**PRE-FINAL CONSTRUCTION INSPECTION REPORT
Groundwater Extraction and Treatment System E-F
Western Groundwater Operable Unit (OU-3)**

**Aerojet General Corporation Superfund Site
Rancho Cordova, California**

February 2012

**Sullivan International Group, Inc.
2750 Womble Road, Suite 100
San Diego, California 92106
(619) 260-1432**

FIGURE 19: SITE PLAN FOR WELL 4555

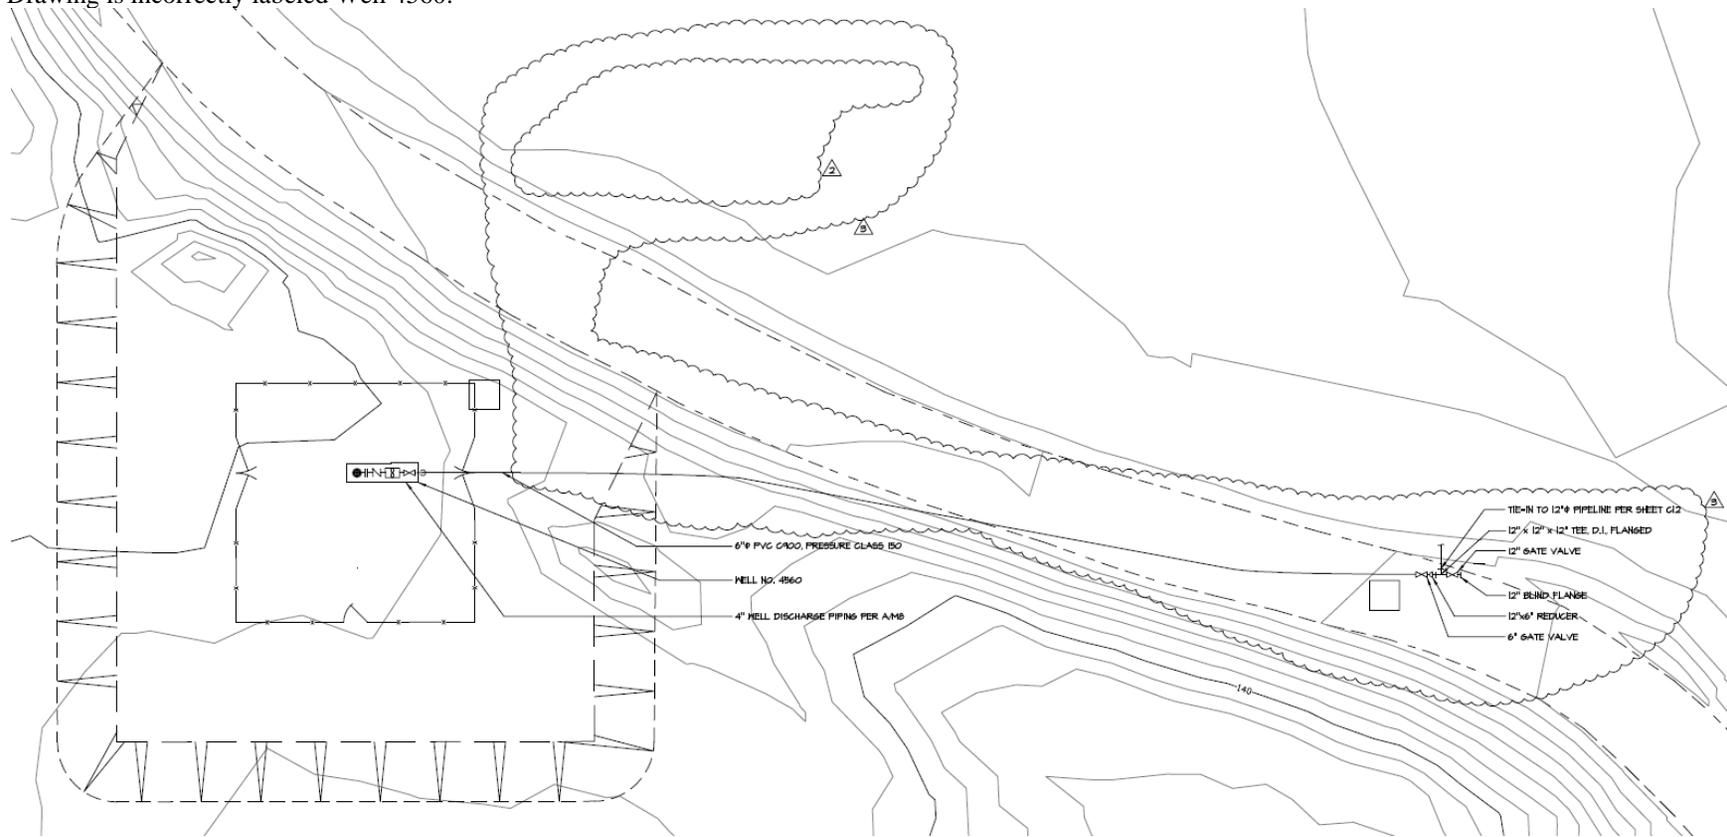
Drawing is incorrectly labeled Well 4560.

FIGURE 25: SECTION VIEW OF WELL 4600

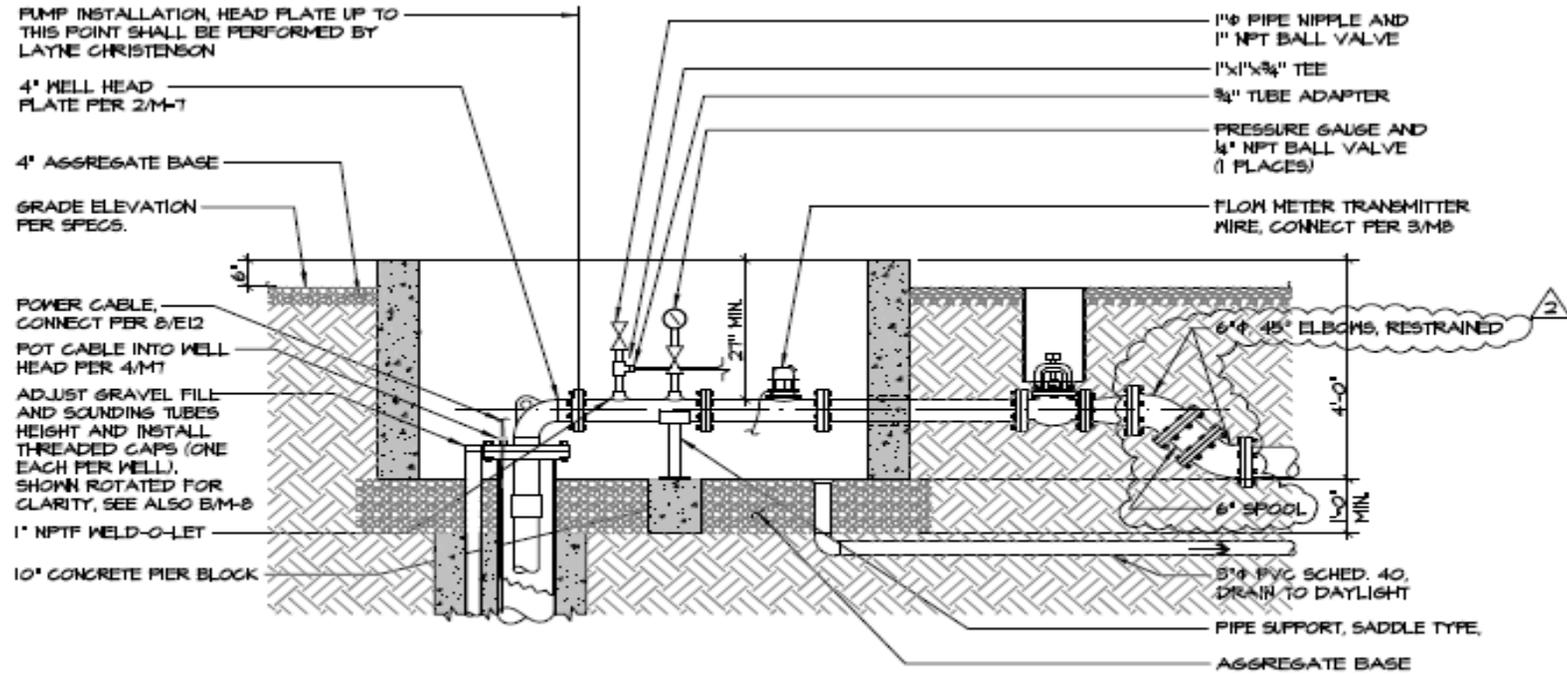
(See [Figure 19](#) for correct sizing of well-head, fittings, valves, and piping.)
